From: Scott Fitinghoff <sfitinghoff@cornerstoneearth.com>
Sent: Thursday, December 27, 2018 10:33 AM
To: Sherry Liu
Cc: Jack Chamberlain; Camille Leung; Steve Monowitz
Subject: RE: BLD2016-00160, 2185 COBBLEHILL PL, LOT 9 SAN MATEO
Attachments: 230-1-6 Geotechnical Consultant Review Form Part 1 Signed 12-27-18.pdf

Subject: BLD2016-00160, 2185 COBBLEHILL PL, LOT 9 SAN MATEO

The Geotechnical Section of Planning and Building Department has conditionally approved the 11/21/2018 plans submitted for Lot 9, which included the riprap details for Lot 10, and 11/27/2018 plans submitted for Lot 11. Please make sure that the final riprap details for Lot 10 match the approved ones in Lot 9.

Date: November 15, 2018
Project No.: 230-1-6
Prepared For: Mr. Jack Chamberlain
TICONDEROGA PARTNERS, LLC
655 Skyway, Suite 230
San Carlos, California 94070
Re: Geotechnical Consultation and
Response to County of San Mateo
Geotechnical Comment
Highlands Estates (Lots 9 and 10)
San Mateo, California
County of San Mateo Geotechnical File Number
BLD2016-00158--00164

Sheet Number: **C9.91**
 OF

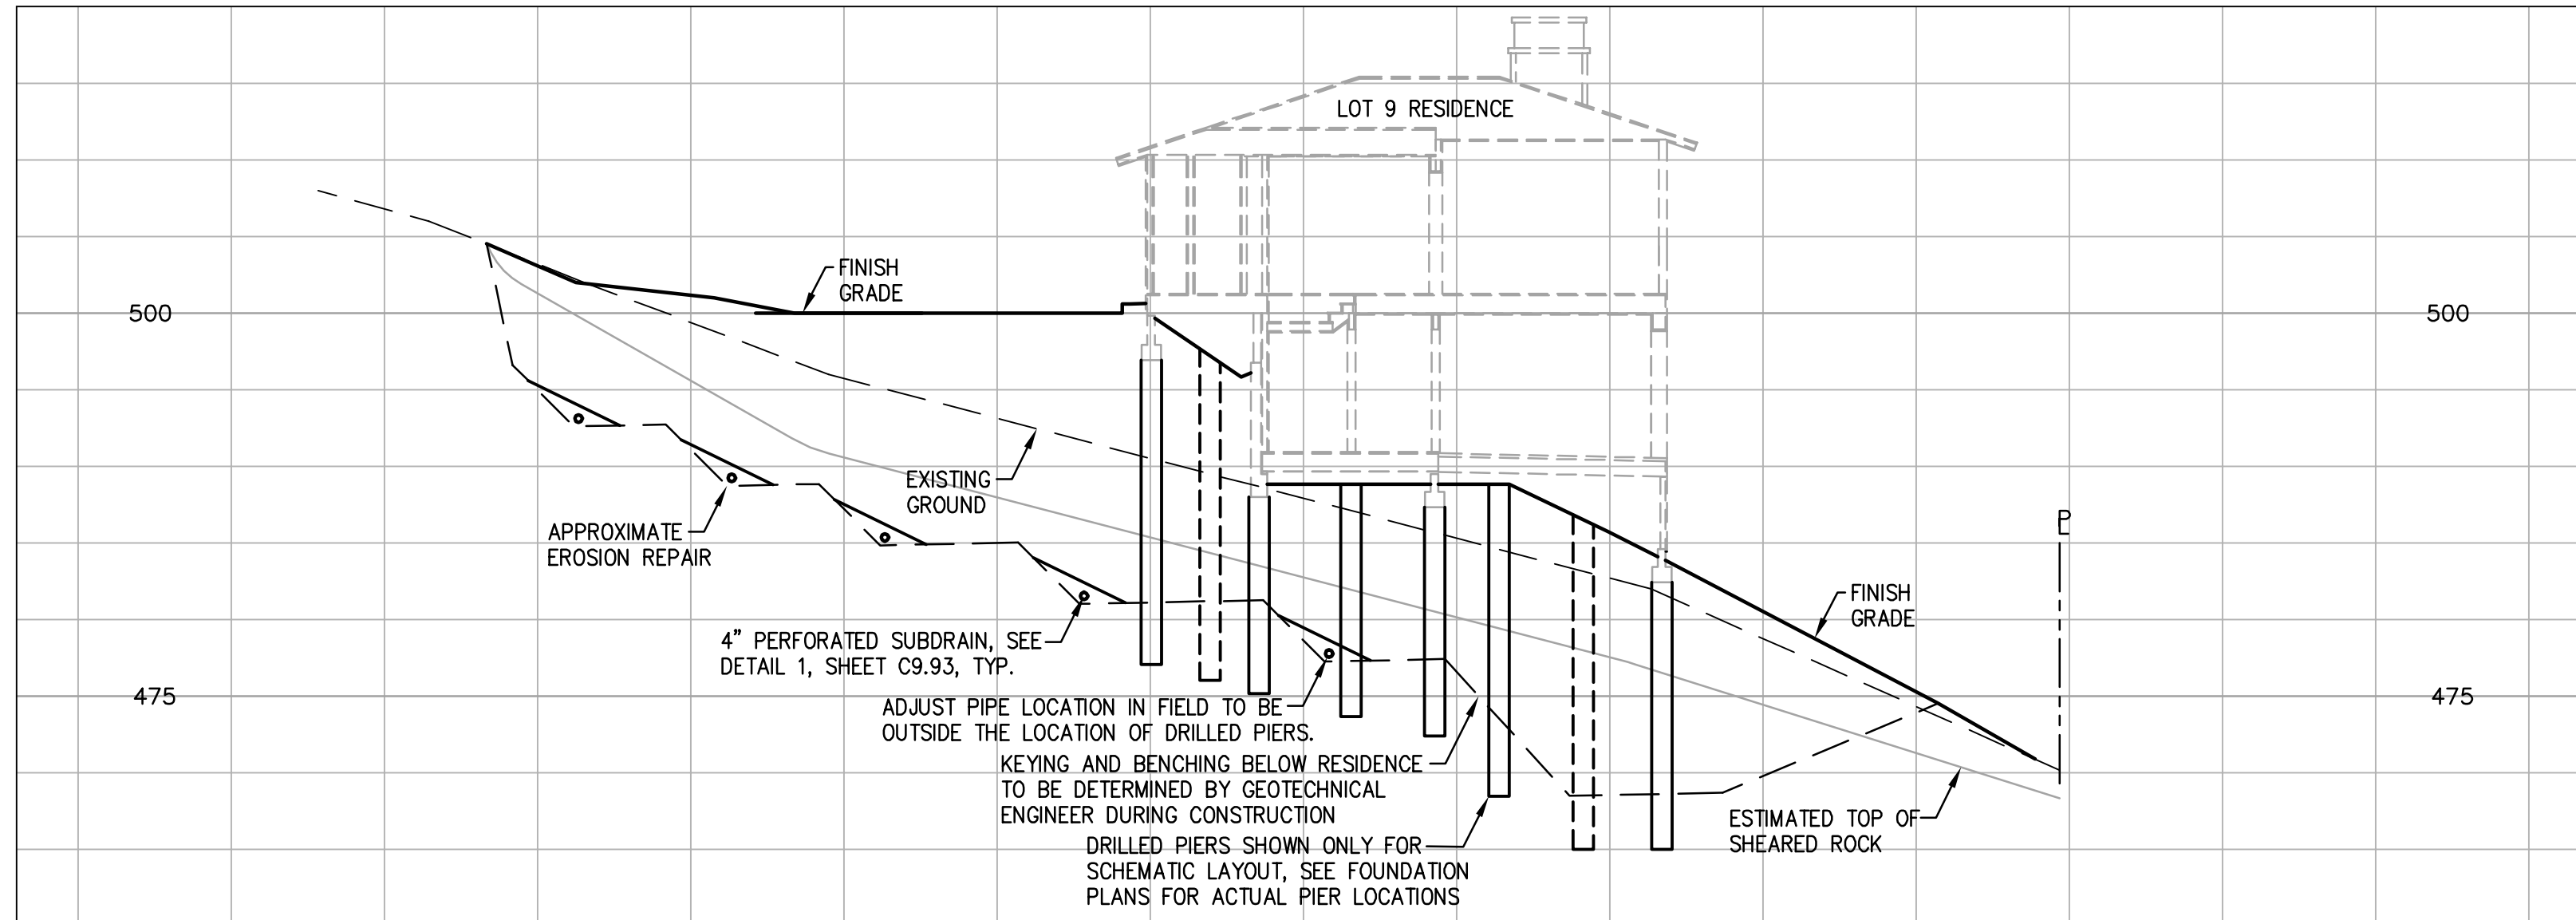
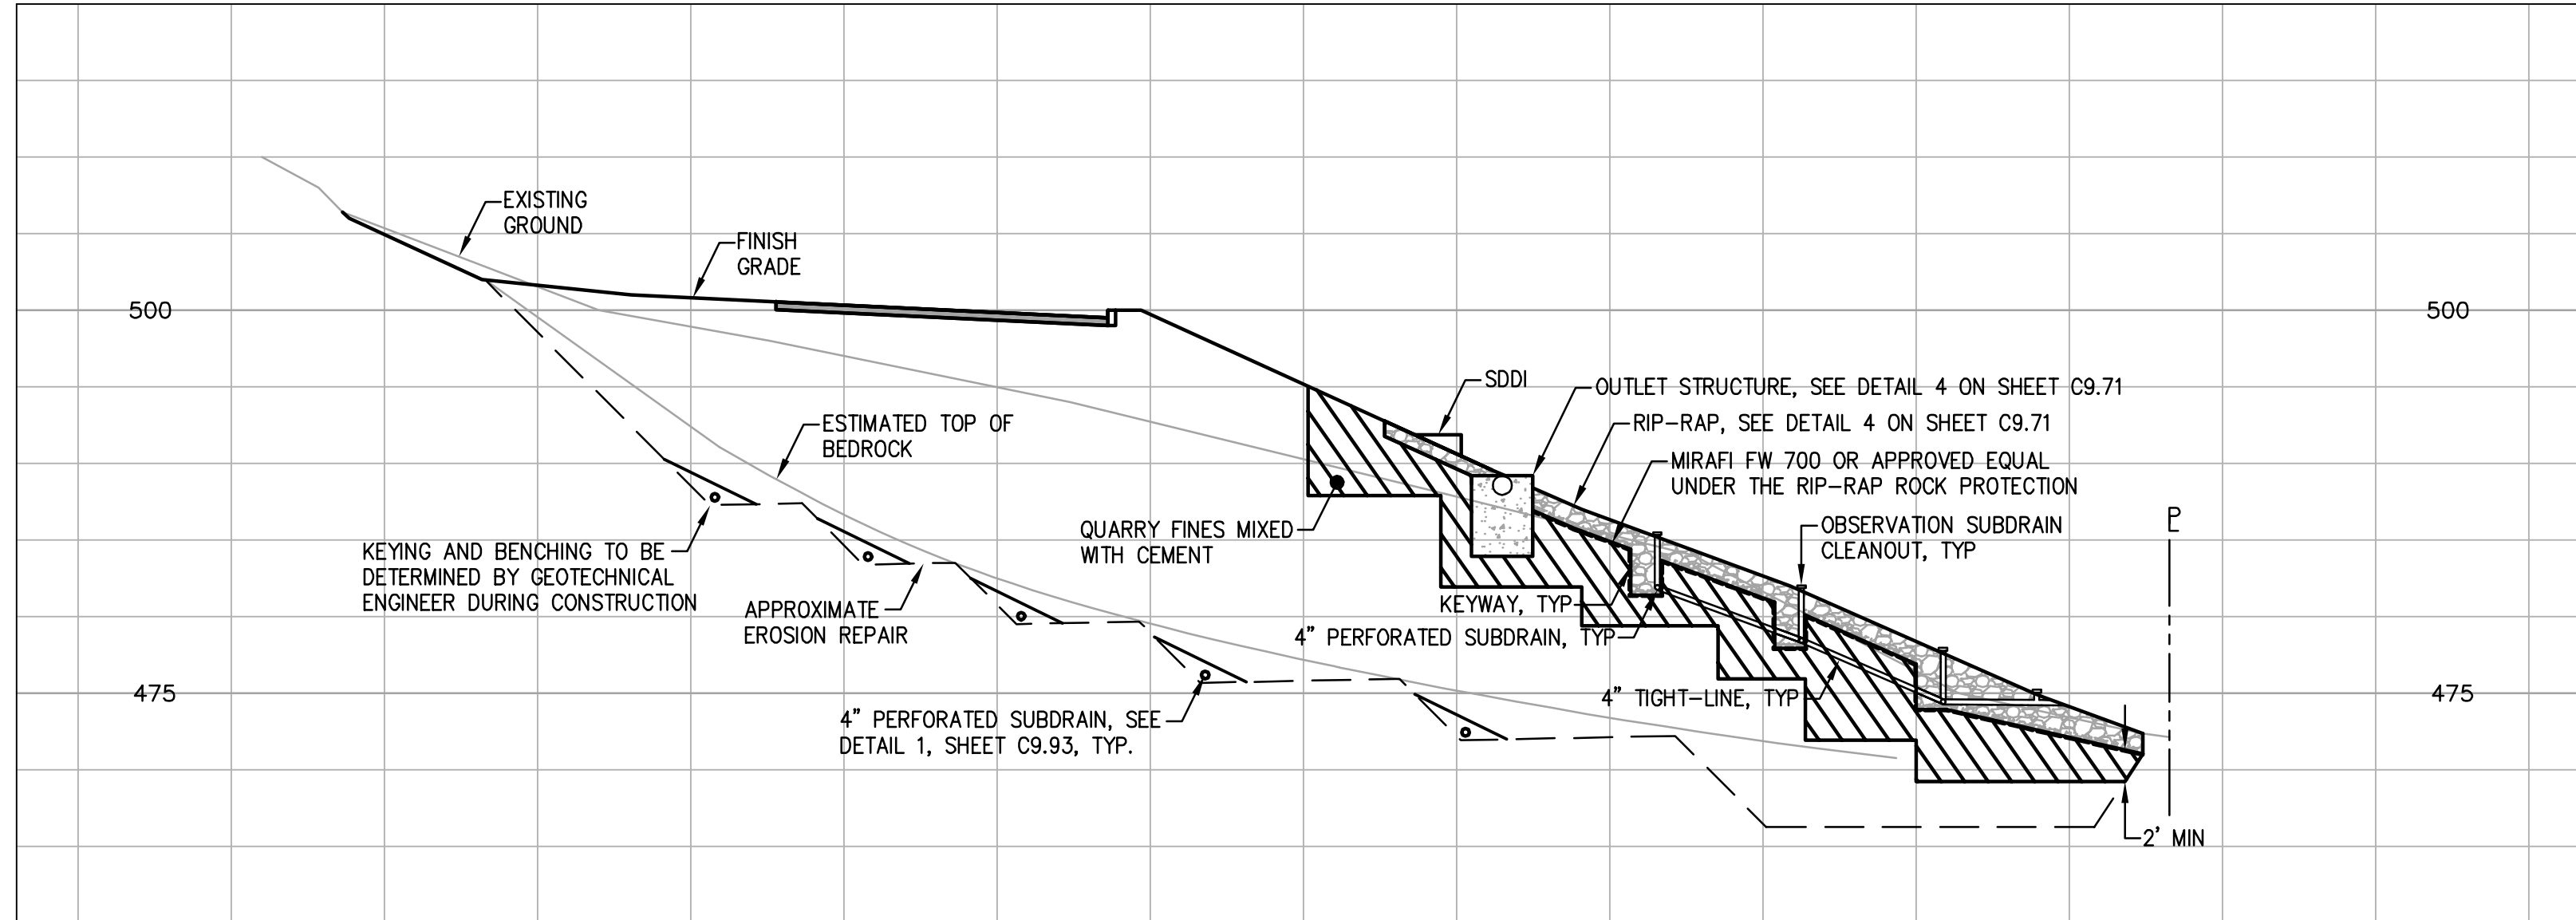
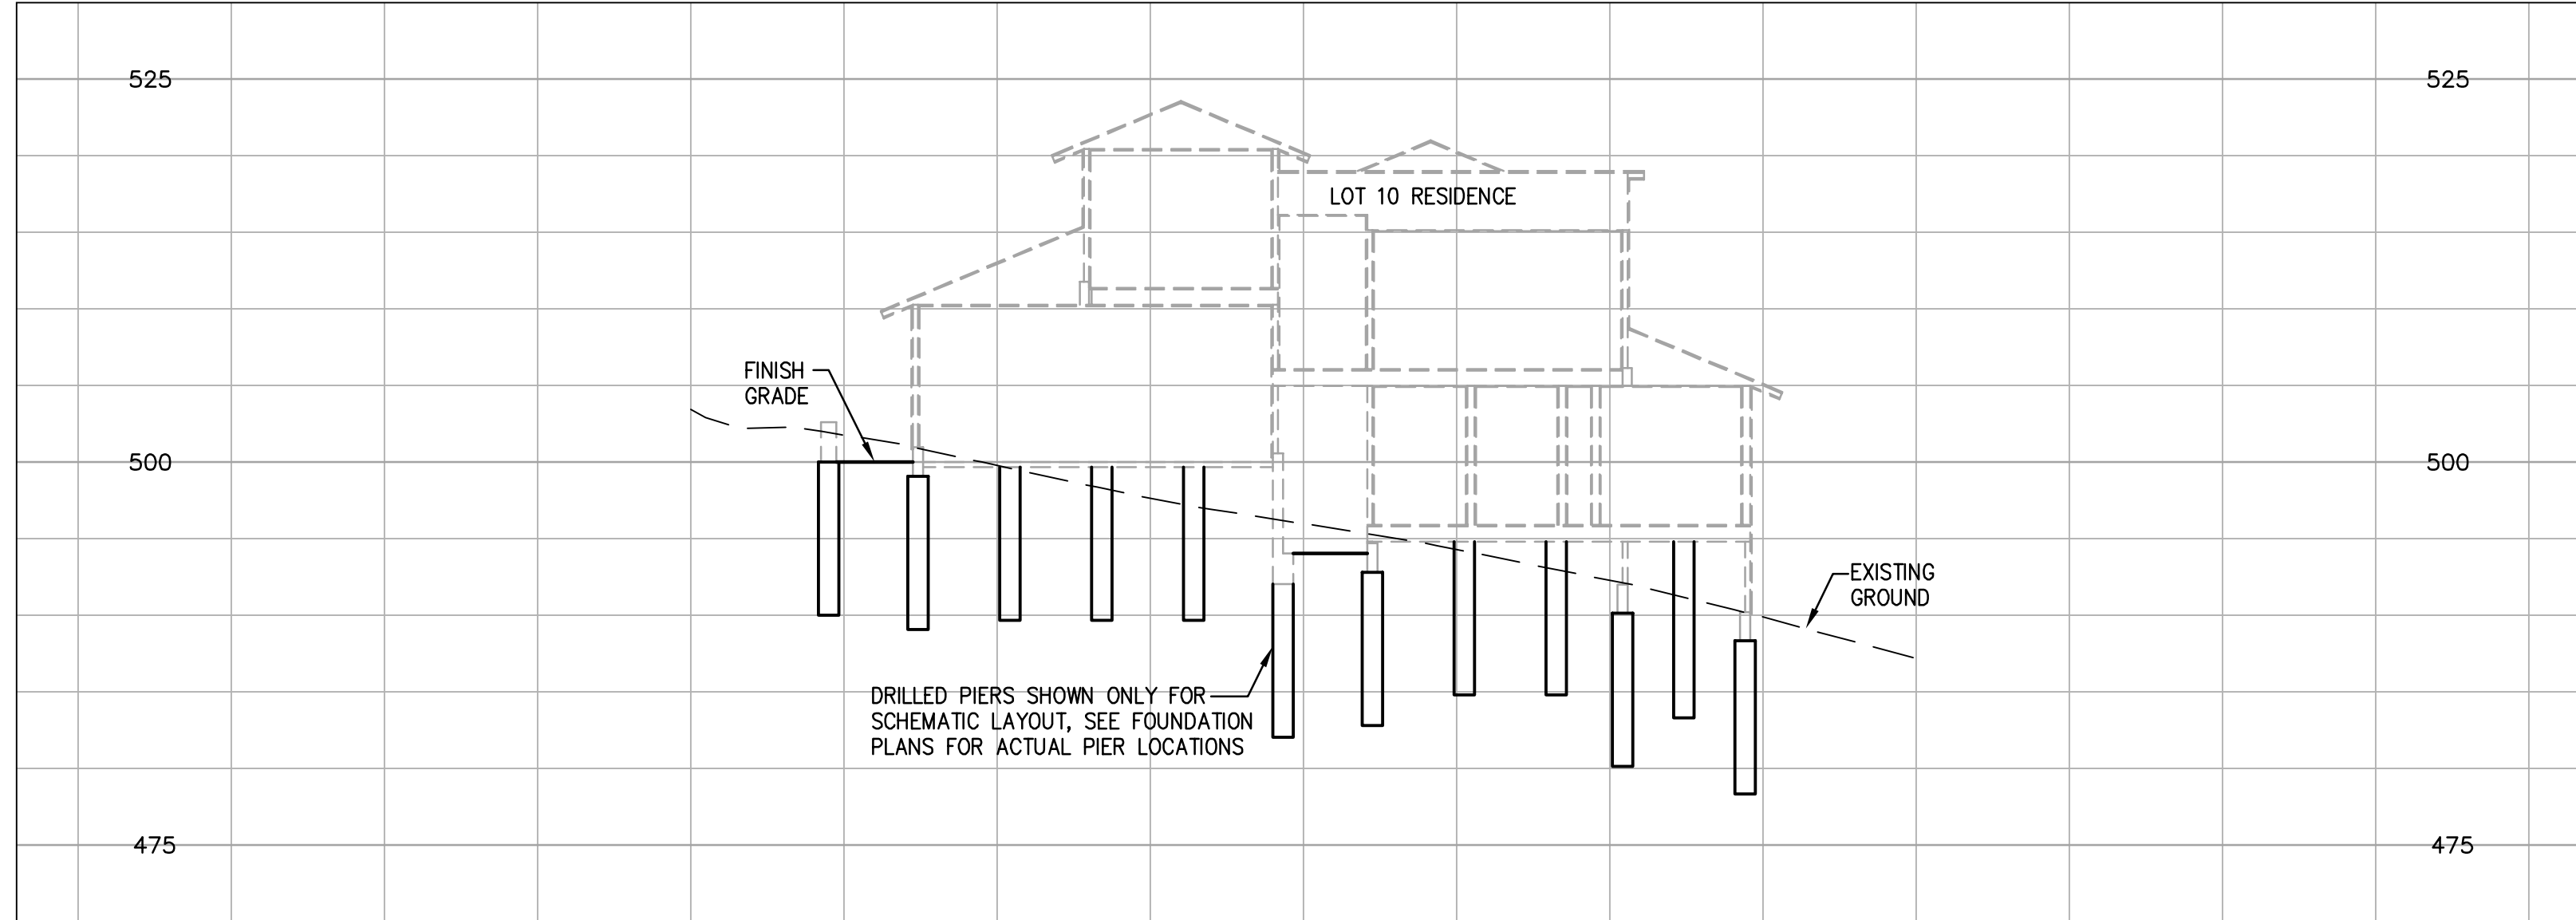
Comment #1: *As the slope below the riprap is 2:1 as shown on BKF Sheet C9.71 for Lot 9 (dated 10-8-18), if water must be discharged across the face of a steep fill slope, then County requires the implementation of one of the following measures:*

As we discussed, the project owner would like to implement the first option to address the above comments. As shown on Sheets C9.71 and C9.93 of the project Civil Plans, the rip rap slope protection will be underlain Marifi FW 700 geotextile fabric or approved equal. We do not recommend the rip rap be hard grouted because that will reduce rock's function of dissipating energy and slowing down the water after being discharged into the rock lined channel. As an alternative to grouting the rock to create an impermeable barrier to isolate the surface water from the underlying fill material, we recommend placing a select fill material consisting of quarry fines mixed with cement beneath the rip rap and geotextile fabric. We have made revisions to Sheets C9.71, C9.91 and C9.93 (see attached) showing the thickness and lateral extent of the select fill material beneath the rock lined channel. We recommend that the Quarry Fines from Stevens Creek Quarry be mixed with bulk cement on-site, moisture conditioned and compacted as recommended in our report. We recommend about 3 percent cement (i.e. 4 pounds of cement per cubic foot of Quarry Fines, compacted in-place). The spreading of the cement would likely need to be done by hand at the job site prior the placement in the fill. Our representative should be on-site during placement to verify the percentage of cement being used in the fill as well as monitoring mixing of the cement, moisture conditioning, and compaction. The material should be compacted within 2 to 4 hours of the initial mixing of the cement. The cement treated select fill material would not be subject to soil creep.
